2008 Annual Report Shepley's Hill Landfill

Devens, Massachusetts

FINAL 2008 Annual Report -

Appendix F

H-ShepayLandtisTaek28MXD-Figure51 mid H-ShepleyLandtisTaek28ExportFigure5-1 pdf August 28, 2009 DWN DJK APC CHKD CA

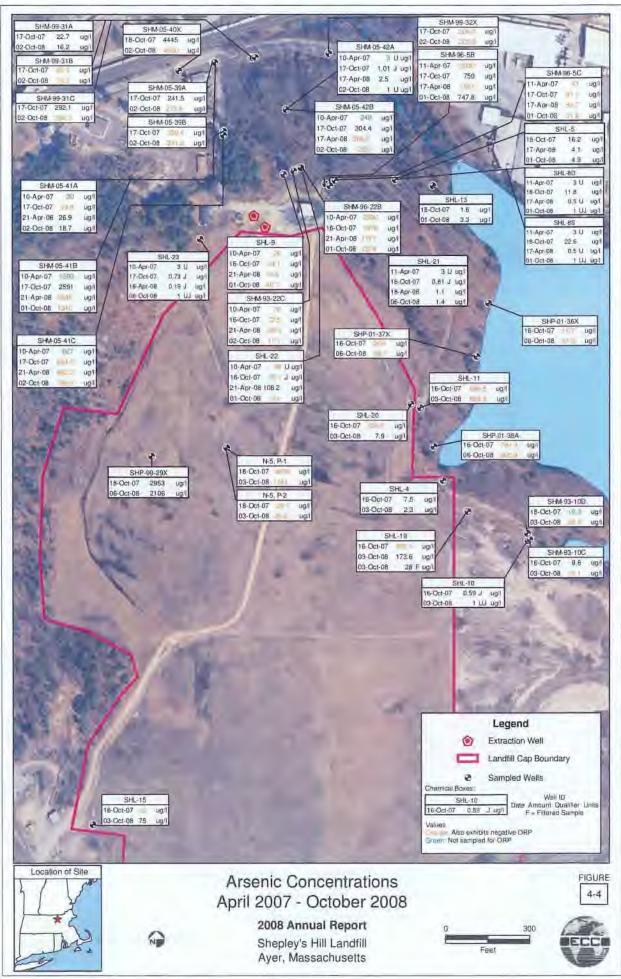
9. Figure 5-1 represents hydraulic gradient vectors using arrows of approximately equal length, providing information on the direction of the vector but not its magnitude. To provide a more complete picture of the flow field, the magnitude of the vectors should be indicated by a written value and/or by appropriately varying the length of the arrows.

Figure 5-2. Correlation Between Long Term Average and Predicted Groundwater Elevations: SHL005 Model (calibrated)

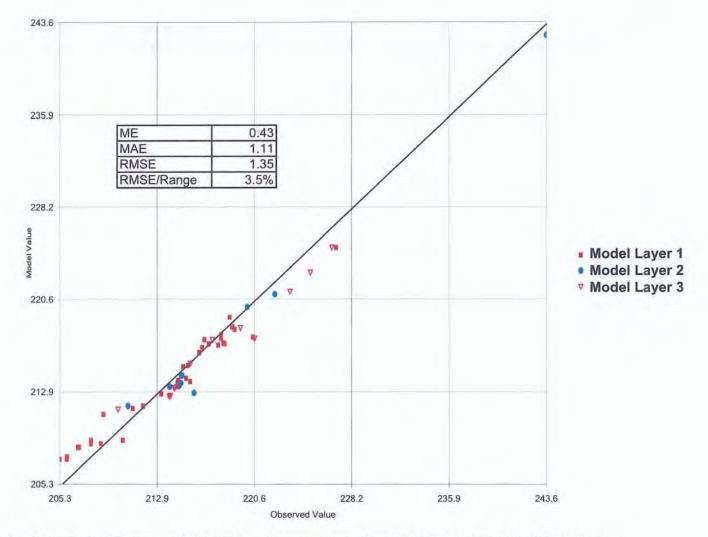
3. The groundwater contours and backward particle tracks shown in Figure 5-2 appear to contradict the report's "full containment" conclusion by suggesting the existence of northerly-trending flowpaths to the east of the extraction wells. Please reconcile the report's conclusion with the data presented in Figure 5-2. The use of forward tracking of particles outside the delineated capture zone may be useful in accomplishing this objective.

**Response:** The recommended particle track exercise has been performed using the updated model discussed in General Comment 1 as shown in revised Figure 5-2 (attached). Reverse particle tracks were used to define the source areas for water arriving at downgradient detections under ambient conditions for comparison to the source areas for water captured by the extraction system. Results indicate the computed capture zone for both the design rate and the average operational rate achieved in 2008 are sufficient to capture those flowpaths leading to detections at SHM-96-22B and SHM-96-5B and, therefore, the conclusion the system is containing the highest arsenic zone is well supported.

Response: As shown in revised Figure 5-2 (attached) the model predicted capture zone at the average operational extraction rate of 34 is sufficient to encompass the ambient flowpaths which lead to the highest detections immediately downgradient at SHM-96-22B and SHM-96-5B. As such this finding is supported. See also response to EPA Specific Comment No. 7.
